**1958 Agreement – Consideration of draft amendments  
to existing Regulations submitted by GRPE**

### **Proposal for the 04 series of amendments to Regulation No. 96 (diesel emission (agricultural tractors))**

#### **Submitted by the Working Party on Pollution and Energy (GRPE)\***

**Definitions of system response: delay time (paragraph 2.1.17.), response time (paragraph 2.1.72.), rise time (paragraph 2.1.73.) and transformation time (paragraph 2.1.89.)**

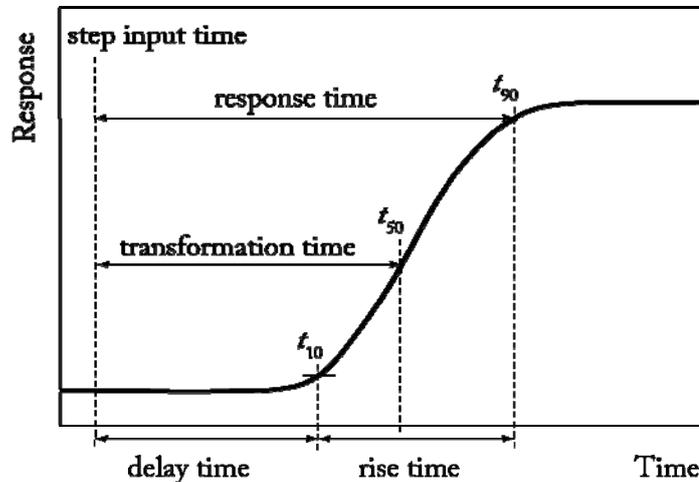
Figure 1, amend to read:

Figure 2  
Control area

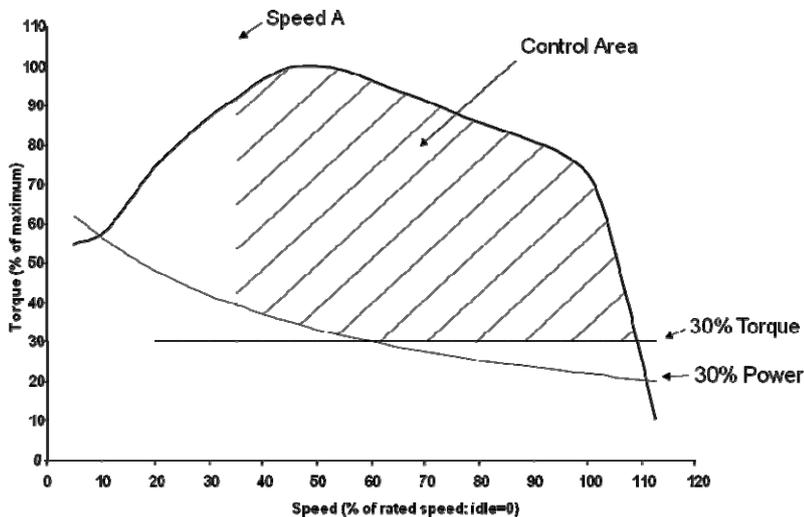
The control area (see figure 2) is defined as follows:

speed range: speed A to high speed;

speed A = low speed + 15 per cent (high speed - low speed);
